SEAL PUSHER SET

RBT400232

REV 2

PUSHER BUSHING

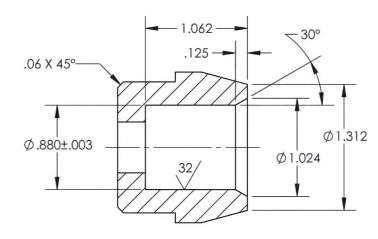
REVISIONS .								
REV	ECR	DESCRIPTION	DATE	INITIAL	APPROVED				
1		-105 CH'D MATERIAL FROM 4140 TO 4140 Q&T, DELETED HEAT TREAT.	4/12/2012	RJC	GE

PUSHER BOLT

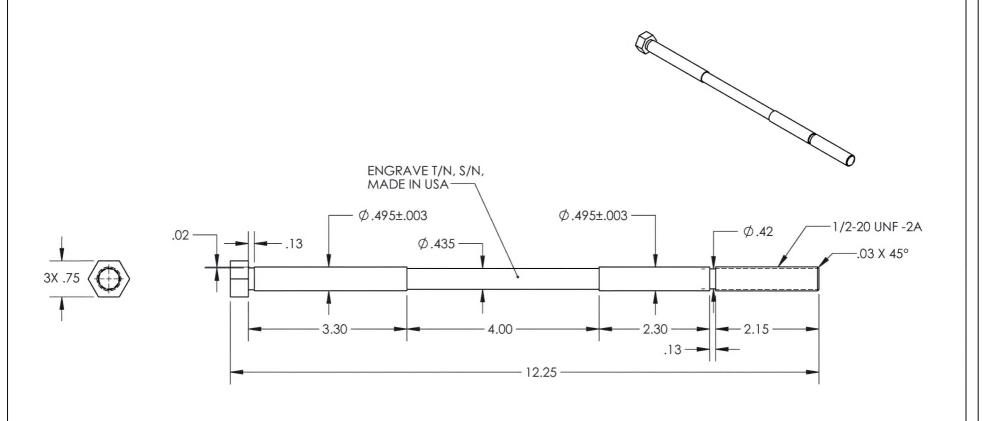
revisions								
REV	ECR	DESCRIPTION	DATE	INITIAL	APPROVED				
В		-107 ADDED OVERALL LENGTH DIM 12.250.	12/2/2011	RJC	SE				
1		-107 CH'D MATERIAL FROM 4140 TO 4140 Q&T, DELETED HEAT TREAT, ADDED MISSING DIM'S Ø.495±.003.	4/12/2012	RJC	GE				
1A		-107 CH'D ENGTRAVE NOTE WAS RBT400232-107 IS RBT400232.	11/7/2012	RJC	SE				
2	15-0201	-107 CH'D DIM WAS .750 IS 3X .75, CH'D OVERALL DIM WAS 12.250 IS 12.25.	8/6/2015	RJC	JAG
